STATE OF WASHINGTON  
DEPARTMENT OF ECOLOGY

September 7, 2007

**Re: Partial Sufficiency and Further Action Determination under  
WAC 173-340-515(5) for the following Hazardous Waste Site:**

- Name: Groat Brothers/Former Service Station
- Address: 608 West Scott Avenue, Woodland, WA 98674
- Facility/Site No.: 5365021
- VCP No.: SW0519

Figure 1  
 GROAT BROTHERS, INC.  
 WOODLAND, WASHINGTON

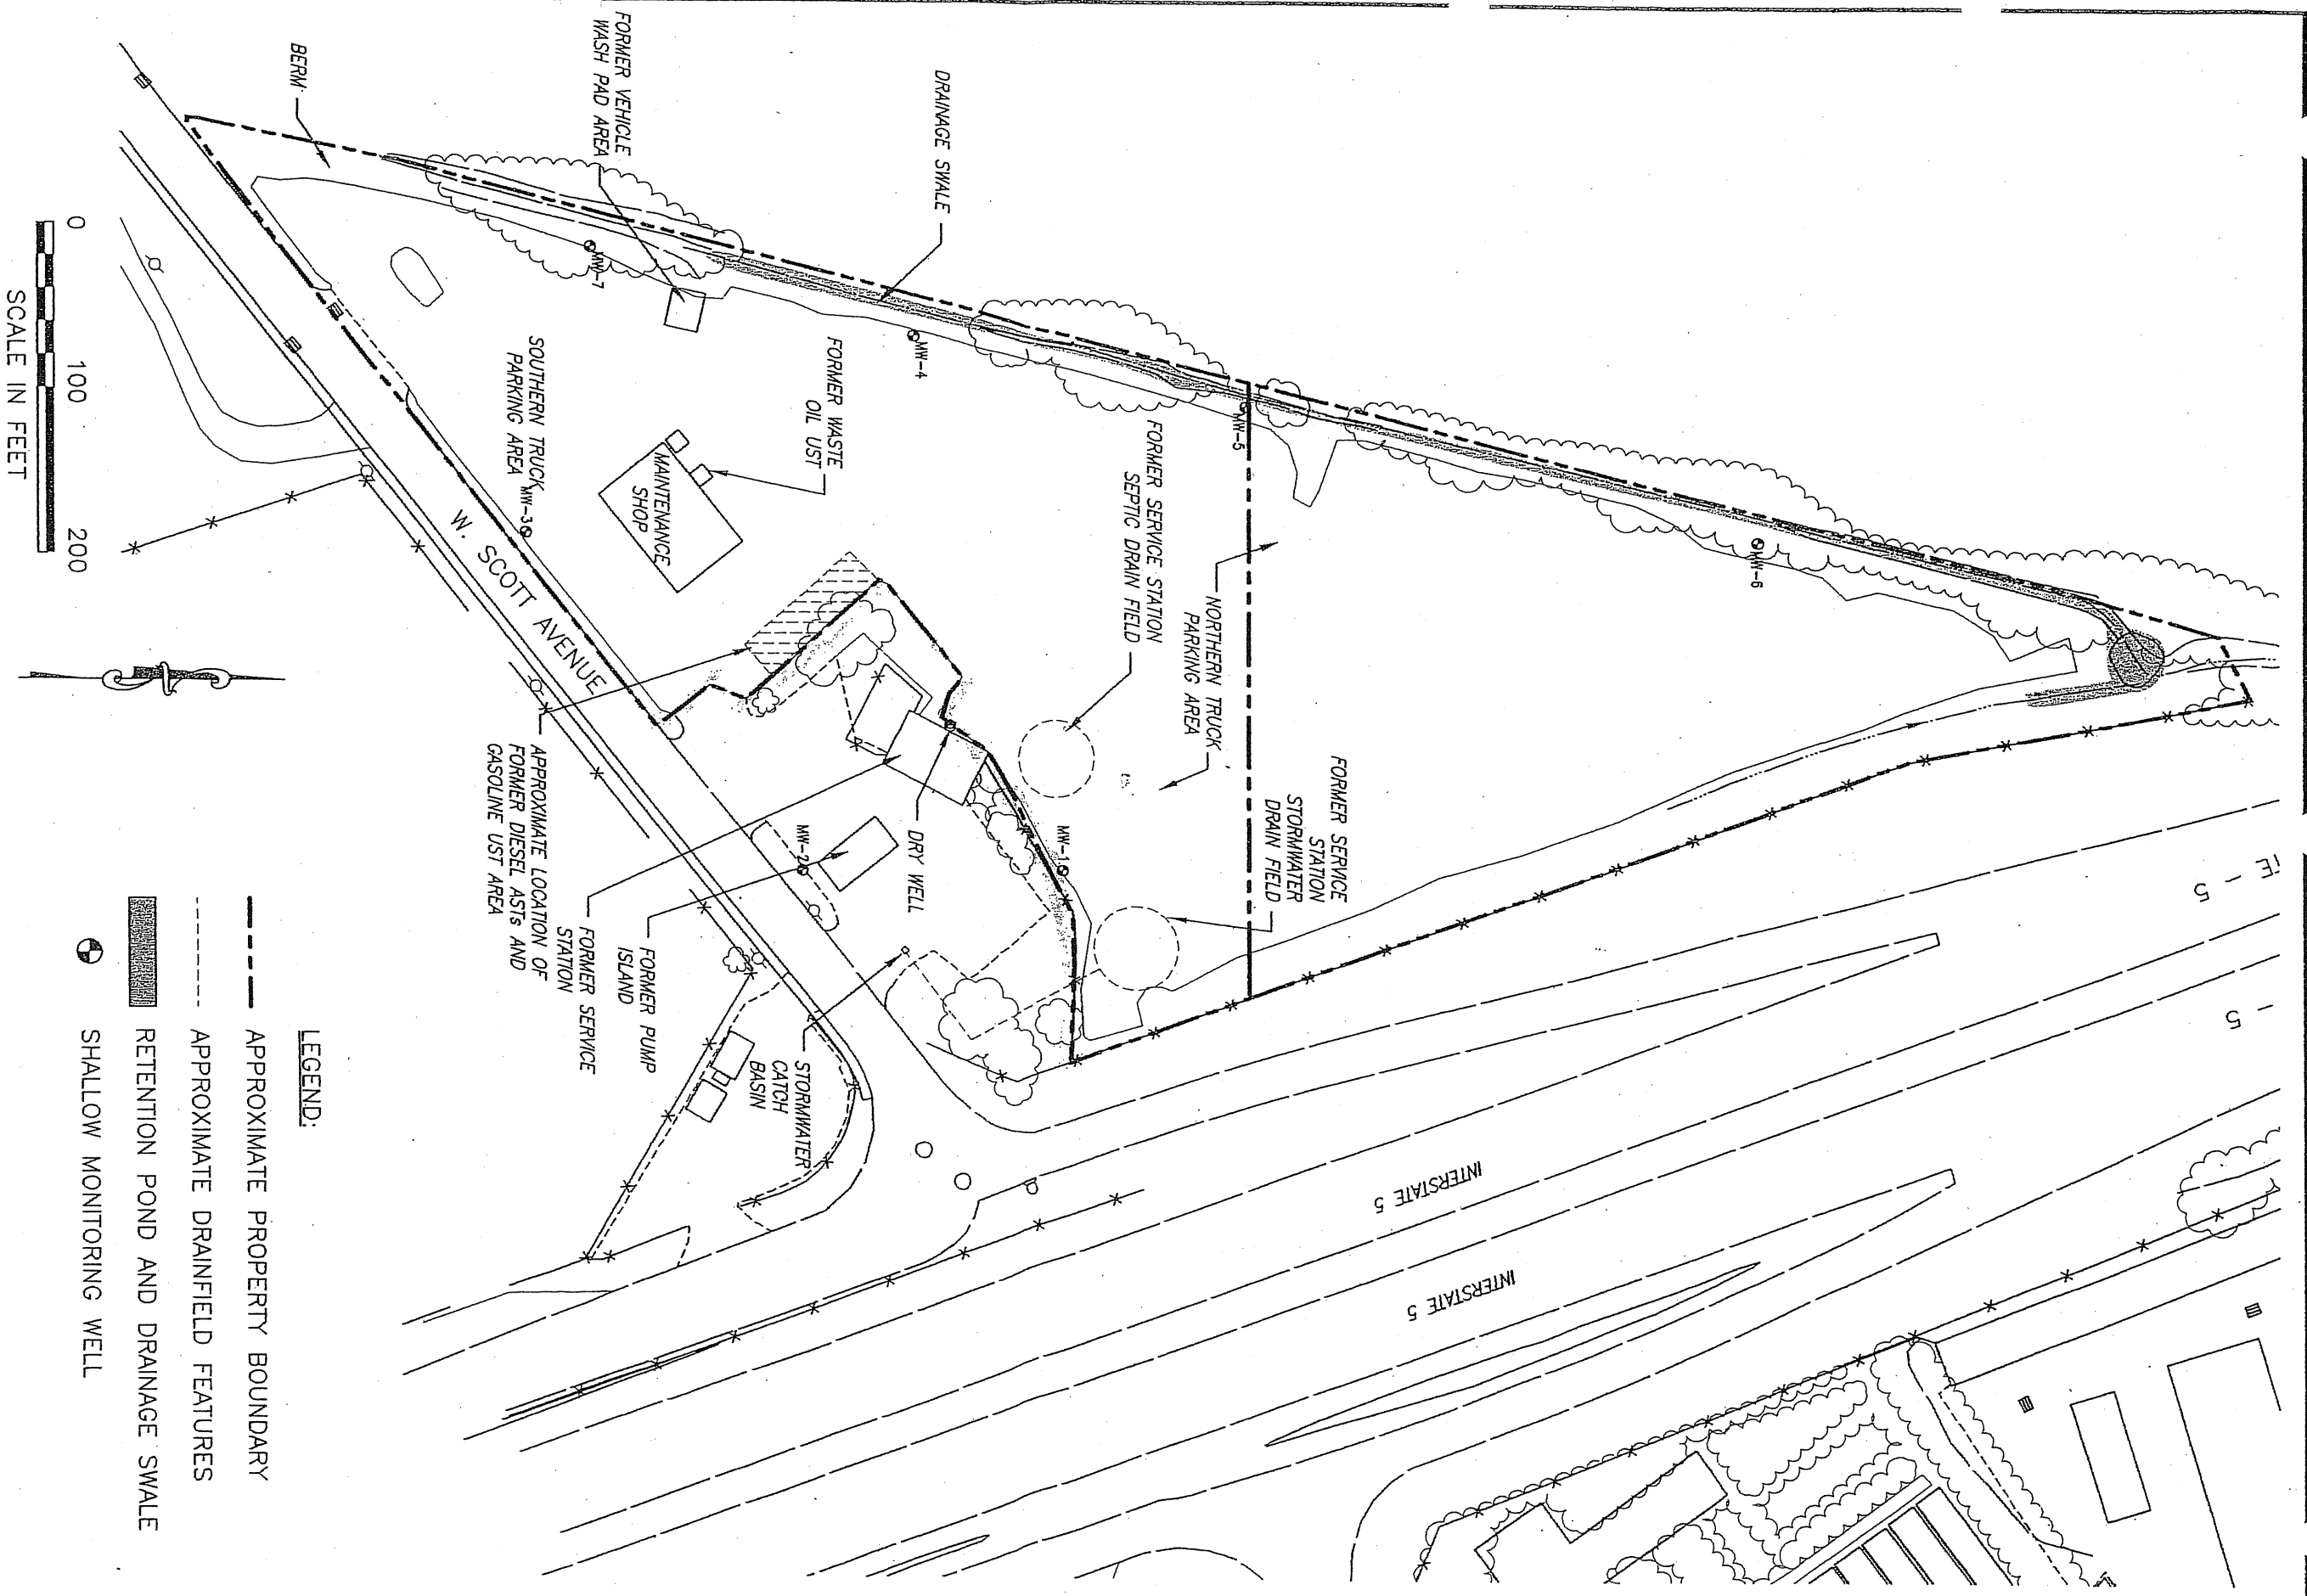
Diesel-range organics were measured at 3,000 µg/l in groundwater under the service station building at test location GP-79. The concentration of Diesel-range organics exceeds the MTCA Method A cleanup level of 500 µg/l at the point of compliance. Therefore, a feasibility study in accordance with WAC 173-340-350 (8) should be conducted to determine if the applicant has considered all the permanent remedial action alternatives with respect to groundwater contamination at GP-79. Ecology will review the remedial action alternative/feasibility study and provide feedback. Table 1 in June 14, 2007 report shows the groundwater samples from DW-1-GW-12.0 and DW-1-GW-20.0 were collected on 10/13/2007. Please correct the date in Table 1 and submit a corrected copy of the Table 1 for Ecology's record.

The soil and groundwater investigation from 2002-2004, did point to surface soil petroleum contamination all below MTCA Method A Cleanup standards. Except in the areas around the dry well and sample No. GP-79 approximately 16 feet southwest of dry well, a groundwater concentration of 3,000 µg/l was detected for diesel-range organics. Figure 1 shows the location of the GP-79. Table A shows the contaminated areas around the dry well. The soil push probe samples were extended to 20 feet bgs and groundwater samples were taken from top of the

Ecology issued an opinion letter on **June 10, 2006**, requiring the applicant to define the extent of groundwater contamination for TCE around the former drywell area and diesel contamination around GP-79. GP-79 showed a

concentration of 3,000 µg/l of diesel-range organics, which is above the groundwater MTCA Method A cleanup level of 500 µg/l. In response to Ecology's opinion letter, the applicant conducted a soil and groundwater study at the site. The results were reported to Ecology on **June 18, 2007**.

In order to determine the extent of soil contamination around GP-79, two borings, GP-86 and GP-87 were completed to depths of 15 feet and 10 feet bgs, respectively. Soil samples were collected at 3.5 feet bgs in GP-86, and GP-87, above the groundwater table. Water samples were collected at intervals within 4-8 feet bgs in GP-86 and within 5.5-9.5 feet bgs in GP-87. Soil and groundwater samples were tested for **Diesel-range and Oil-range organics**. All the test results for the soil and groundwater showed non-detect. It appears the diesel contamination is localized under the building around GP-79.
